# UNITED STATES PATENT AND TRADEMARK OFFICE

| APPLICATION NO.  | FILING DATE | FIRST NAMED INVENTOR | ATTORNEY DOCKET NO.         | CONFIRMATION NO. |
|--|-------------|----------------------|-----------------------------|------------------|
| 10/026,477   | 12/27/2001  | Hong Suk Yoo         | 8733.561.00                 | 7762             |

# Office Action Summary

## **DETAILED ACTION**

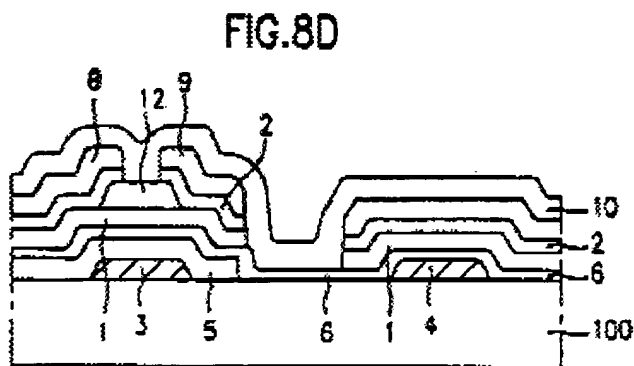
As to claim 15, Moon discloses in the 5<sup>th</sup> embodiment (col. 6, lines 8-63 and Figures 8A-8D) a liquid crystal display (LCD) device comprising:

- a first substrate , 100; a second substrate;
- a liquid crystal layer formed between the first and second substrates;
- a storage capacitor, (combination of 4, 6, 1, 2, and unlabeled 9; col. 6, lines 10-30), formed in a first region of the first substrate;

- a thin film transistor formed in a second region of the first substrate.
- a gate electrode, 3, for the thin film transistor and a storage capacitor electrode, 4, spaced apart from the gate electrode, both formed on the first substrate;

- a first insulating layer, 5, formed on the surface of the first substrate except an upper portion of the storage capacitor electrode;
- a second insulating layer, 6, formed on the first insulating layer and the storage capacitor electrode;

- a conductive layer (unlabeled layer between layers 2 and 10 above 4) formed on the second insulating layer overlapping the storage capacitor electrode in the first region;

- and
- a pixel electrode (not shown, inherent to comprise functional device) electrically connected to the conductive layer and a drain electrode, 9, on the thin film transistor.

Moon does not explicitly disclose a first insulating layer, 5, formed on an entire surface of the first substrate except an upper portion of the storage capacitor electrode. However, the teachings of Moon are considered to render the claimed invention obvious to those having ordinary skill in the art of liquid crystals, since there is no disclosed functional significance to the minor structural difference as claimed in either Moon or Applicant's enabling disclosure.

As to claim 17, Moon discloses in Figure 8D the liquid crystal display device as claimed in claim 15, further comprising a semiconductor layer, 1, formed above the second insulating layer in the second region and used as a channel of the thin film transistor.

As to claim 18, Moon discloses in Figure 8D the liquid crystal display device as claimed in claim 17, further comprising a source electrode, 8, and a drain electrode, 9, opposing each other and formed above the semiconductor layer.

As to claim 19, Moon discloses in Figure 8D the liquid crystal display device as claimed in claim 18, wherein the conductive layer (unlabeled 9 between 2 and 10) is of the same material as the source and drain electrodes and formed on the second insulating layer in the first region.

As to claim 20, Moon discloses in Figure 8D the liquid crystal display device as claimed in claim 18, further comprising an ohmic contact layer, 2, formed at an interface between the source and drain electrodes and the semiconductor layer.

As to claim 21, Moon discloses in Figure 8D the liquid crystal display device as claimed in claim 18, further comprising a passivation layer, 10, having a contact hole and formed on an entire surface including the conductive layer and the source and drain electrodes to expose upper portions of the drain electrode and the conductive layer.

As to claim 22, Moon discloses in Figure 8D the liquid crystal display device as claimed in claim 21, wherein the pixel electrode electrically connects to the drain electrode and the conductive layer through the contact hole (inherent to a functional

FIG. 2

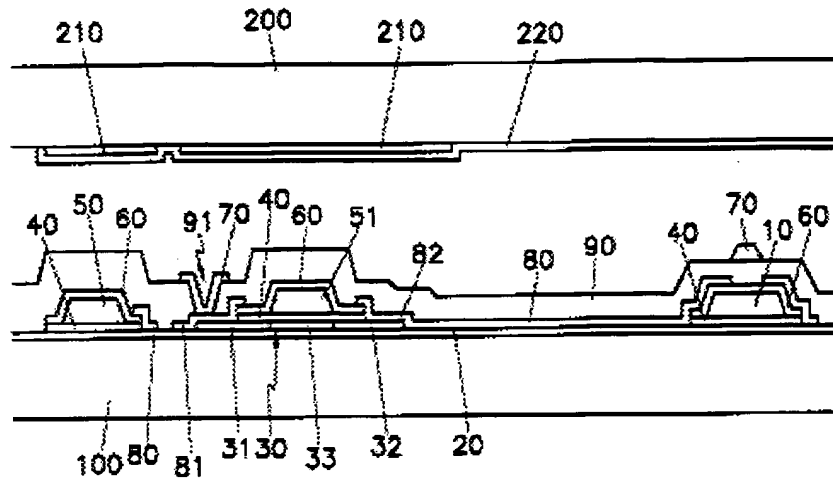
For example, Hwang teaches in the background of the invention, and in the first preferred embodiment, a second substrate, 200, comprising a plurality of Red (R), green (G), and blue (B) color filter patterns (col. 1, lines 26-33 and col. 2, lines 22-28; and Figure 2) for displaying colors; a black matrix, 210, for dividing the respective color filter patterns and for shielding light; and a common electrode, 220, for applying a voltage to the liquid crystal layer formed on the entire surface (col. 3, lines 24-26) including the black matrix and the color filter patterns, to achieve good color display performance with good contrast and good aperture ratio.

Hwang is evidence that ordinary workers in the art of liquid crystals would find the reason, suggestion, or motivation to add a second substrate comprising a plurality of Red (R), green (G), and blue (B) color filter patterns for displaying colors; a black matrix for dividing the respective color filter patterns and for shielding light; and a common electrode for applying a voltage to the liquid crystal layer formed on the entire surface including the black matrix and the color filter patterns, to achieve good color display performance with good contrast and good aperture ratio.
